**RE: Application for Zoning By-law Amendment and Draft Plan of Subdivision  
750 Lockhart Road, City of Barrie**

LSRCA FIRST SUBMISSION NATURAL HERITAGE REVIEW  
 750 Lockhart Road – Barrie (APID402883)  
 July 25, 2019

LSRCA ENGINEERING REVIEW (1<sup>ST</sup> SUBMISSION)  
Ballymore 750 Lockhart Road APID 402883  
July 24, 2019

LSRCA FIRST SUBMISSION HYDROGEOLOGY REVIEW  
 Ballymore - 750 Lockhart Road – Barrie (APID402883)  
 June 7, 2019

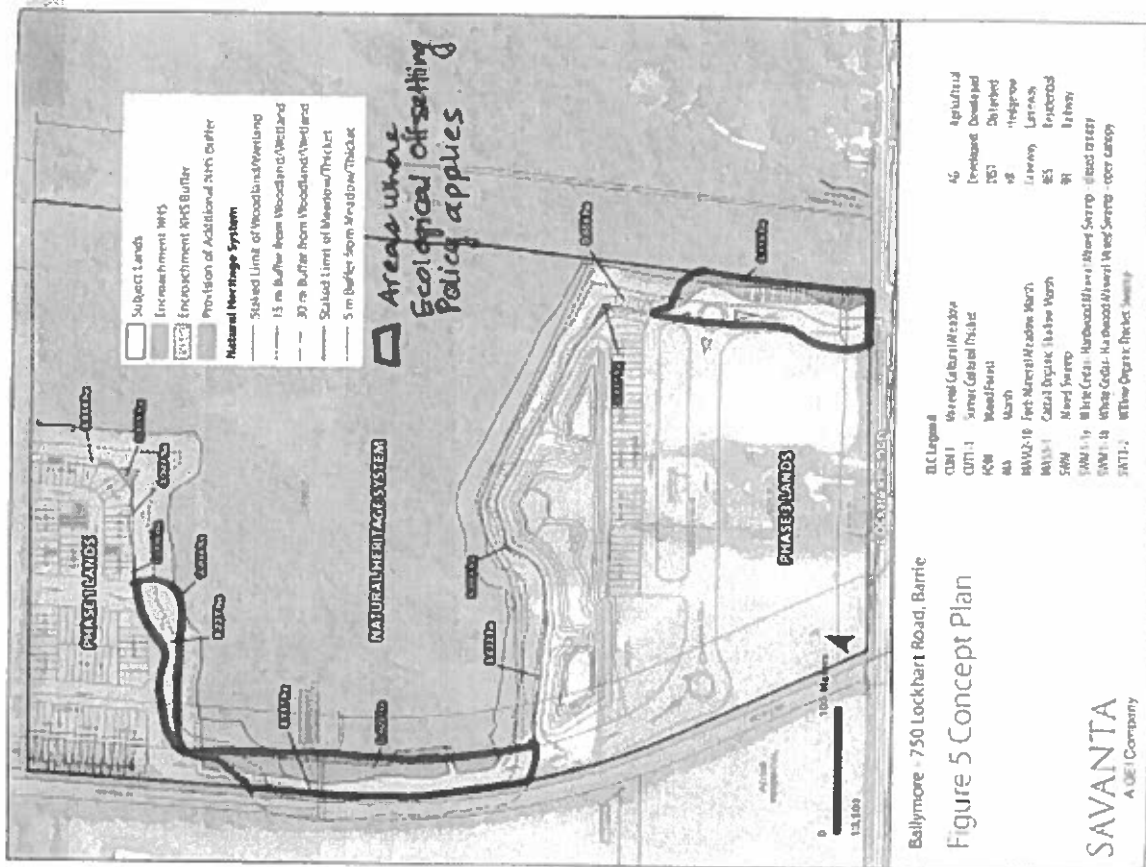
#	Report/ Drawing	Section	Pg#	LSRCA COMMENT (July 25, 2019)	APPLICANT RESPONSE (DATE)
<b>Documents Reviewed:</b>					
<b>Natural Heritage Evaluation, 750 Lockhart Road, Barrie, prepared by Savanta, dated March 2019</b>					
	NHE			<p>A preliminary Ecological Offsetting Strategy (EOS) is required to address the unavoidable loss of wetland feature and associated vegetation protection zone (VPZ), as per LSRCA Ecological Offsetting Policy (May 2017). The EOS should identify the total area of loss to be compensated for and the general location and methods for how it will be replaced. Please consider the following when developing the EOS:</p> <ul style="list-style-type: none"> <li>- Figure 5. in the NHE shows the areas within the natural heritage features and VPZ that will be either disturbed or lost. Please note that minor encroachment into the buffer area, where naturalized vegetation is absent (e.g. farm field), is permitted. These areas must be restored and naturalized, but the Ecological Offsetting Policy would not apply.</li> <li>- The VPZ has been reduced and/or increased in various areas to provide an averaged 30m buffer to natural heritage features. Where the VPZ has been reduced, the Ecological Offsetting Policy would not apply to these areas as an equivalent gain has been provided elsewhere.</li> <li>- The Ecological Offsetting Policy applies to the loss of woodland, wetland and associated VPZ. It does not apply to the loss of thicket and meadow.</li> </ul> <p>Please see the markup of Figure 5 below which highlights the areas where the Ecological Offsetting Policy would apply.</p>
